Engineers Comments Regarding Surface Water Drainage

Application Reference:	BN/53/26/DOC	Reviewer Reference:	ADC/EXT2/D2134/107
Planning Officer:	Simon Davis	Date of Review:	29.04.2026
Site Name:	Land at Angels Nursery Yapton Road Barnham PO22 0AY		
Application Description:	Approval of details reserved by condition following the grant of BN/84/20/PL relating to conditions 3-as built drawings and 5-updated copy of management manual		
Assessment Number:	1

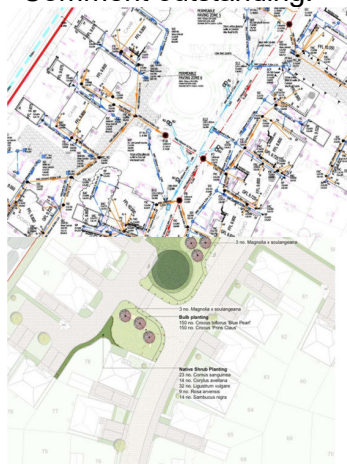
ADC Response
[BN/58/24/DOC]
10/09/2024:
The landscaping drawing (P19-2044_02) for the public open space appears to be based on a different site layout. Please provide the correct landscaping drawing.

ADC Response
(BN/152/24/DOC)
15/01/2025
Landscaping drawing P19-2044_02 has been supplied as before. In addition another landscaping drawing for 'enhanced proposals' (Covey Design) has been supplied reference 17890 02 Rev B.

Both drawings however are based on a different site layouts compared to the SUDS/engineering plans that we understand have been implemented.

Please provide the landscaping proposals

appears to be conflicting with one of the landscaping proposals for the access to plot 81? Has landscaping been installed as per these drawings?

Comment outstanding.

that have/will be installed to the final site layout. Designer Response (BN/152/24/DOC) 04/02/2025 The approved landscaping plans are clearly defined in section 2.1.4 within the report are presented in appendix A for reference. These are the drawings that are documented in associated planning decision notice/ approval. ADC Response (BN/152/24/DOC) 23/04/2025 To clarify the earlier comment, it would appear that both drawings however appear to show different planting proposals so there is some uncertainty of planting to be reviewed in vicinity of the drainage and SUDS features. Please provide the landscaping proposals that have/will be installed to the final site layout.				
--	--	--	--	--	--
